Re: Oyster Creek Nuclear Generating Station
Docket No. 50-219
SEP Structural Topics

Transmitted herewith are our responses to your letter of July 16, 1969 which requested additional information concerning the following SEP structural topics:

ATTACHMENT A
OYSTER CREEK NUCLEAR GENERATING STATION
SEP STRUCTURAL TOPICS

OYSTER CREEK NUCLEAR GENERATING STATION
Additional Information
Structural Topics

FIGURE C-1

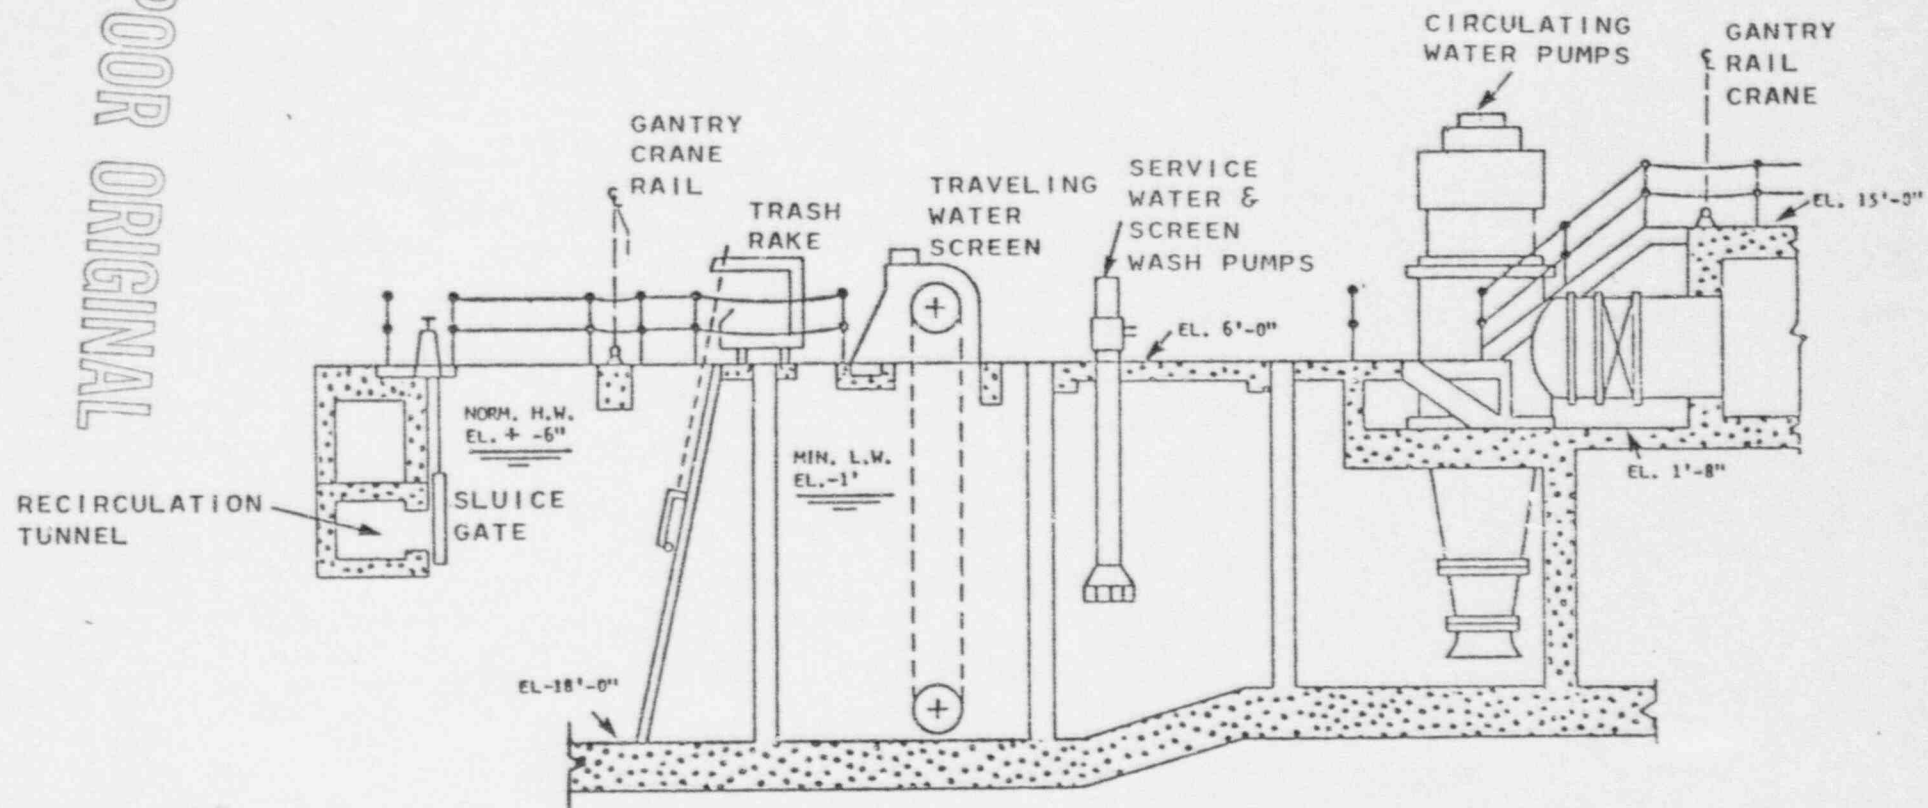
- 9c. Either show that all plant features outside of the barrier provided by the reactor-turbine building complex are not necessary for cooldown, or that all features outside the reactor-turbine building complex can withstand very severe wave action, or provide a detailed wave analysis that will demonstrate that during a postulated PMH wave action on these exterior facilities will not impair their functionality.

The locations of these plant features are shown in Figure C-1. The circulating water and service water pumps are mounted on a deck at Elevation +6 feet MSL above the intake structure. An elevation section of the intake structure is shown in Figure C-2. The standby diesels are located on the plant grade at Elevation +23 feet MSL alongside the discharge canal.

The wave runup elevations and wave forces are considered conservative estimates as no credit was taken for the presence of obstructions on the intake structure deck or the lower plant grade, which are clearly indicated on Figure C-1 and which certainly would contribute to decreased runup and forces due to friction and turbulence.
